Bango Wind Farm

Response to Submissions

May 2017

Figure 3: Areas Targeted for Turbine removal

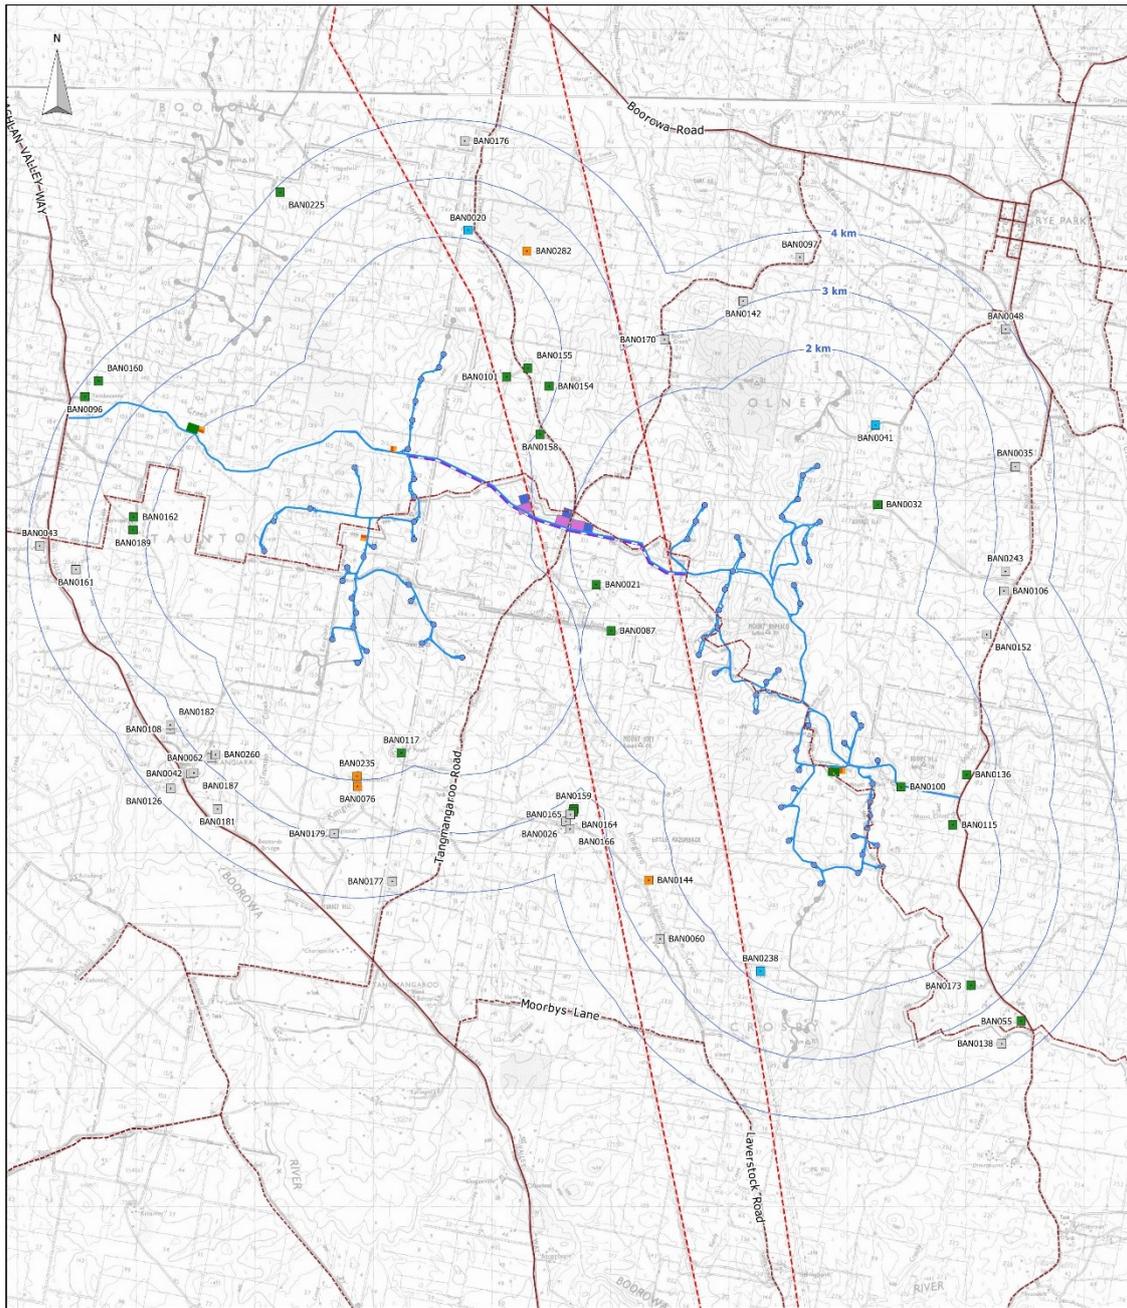
The following figures show the layout response to submissions. More detail is provided in the Bango Wind Farm Amended Development Application.

Figure 1: Predicted noise level contours at 10m/s wind speed.

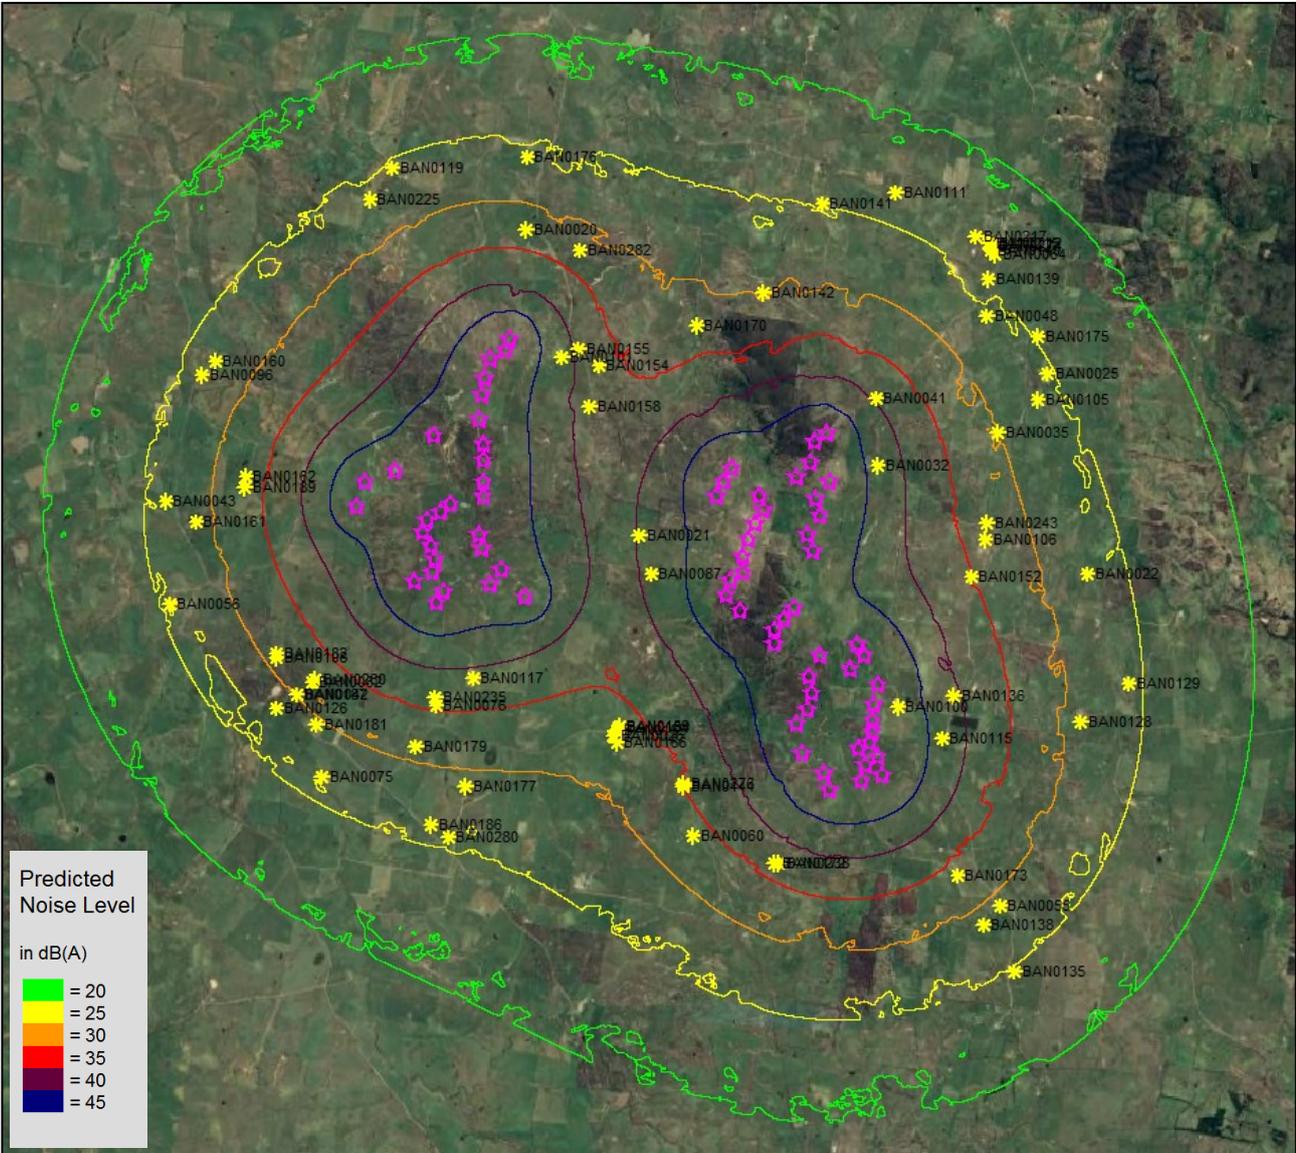
The predicted noise levels and the resultant noise criteria are summarised in Table 4. Predicted noise level contours corresponding to 10 m/s wind speed (results in the highest noise levels) are provided in Figure 1.

Based on the predictions, the noise from layout LO1 will comply with the criteria established in accordance with the SA Guidelines with a base level of 35 dB(A), at all non-involved dwellings except at BAN238. To achieve the requirements of the SA Guidelines at BAN238, an agreement with the landholder will need to be established (it is understood that this is currently being negotiated), otherwise the wind farm layout will need to be modified (removal of the two closest turbines, or relocation of the turbines) such that the predicted noise levels at all non-involved dwellings achieve the established criteria.
